PRODUIT: MILLENIUM 3.0
 PRODUCT: MILLENIUM 3.0

OBJET: FREINAGE DE LA BROCHE
 SUBJECT: SPINDLE BRAKE

IMPERATIVE MODIFICATION: SAFETY PROBLEM
M3.0 WITH SERIAL NUMBER BETWEEN 247 AND 348

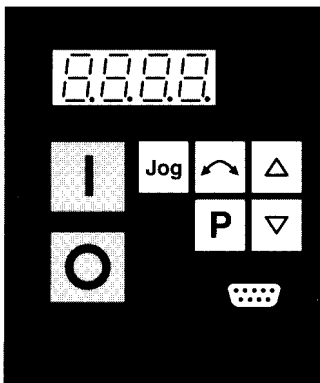
Pushing on the spindle brake button when changing tooling may generate a sudden spindle rotation. This phenomenon is rare but was observed in some cases.

Obviously this is dangerous for the operator, making the following modification necessary.

The parameters of the spindle variator must be changed, so the spindle brake works in a safe way. It is then necessary to modify the value of 4 parameters: P9=2, P53=15, P54=6, P55=7 according to the following procedure:

- Press **P** P000 should appear.
- Press \triangle Go to P009.
- Press **P** 0000 or 0001 should appear.
- Press \triangle Go to 0002.
- Press **P** P009 should appear.
- Press \triangle Go to P053.
- Press **P** 0000 should appear.
- Press \triangle Go to 0015.
- Press **P** P053 should appear.
- Press \triangle Go to P054.
- Press **P** 0000 should appear.
- Press \triangle Go to 0006.
- Press **P** P054 should appear.
- Press \triangle Go to P055.
- Press **P** 0015 should appear.
- Press ∇ Go to 0007.
- Press **P** P055 should appear.
- Press ∇ Go to P000.
- Press **P** 0.0 should appear.
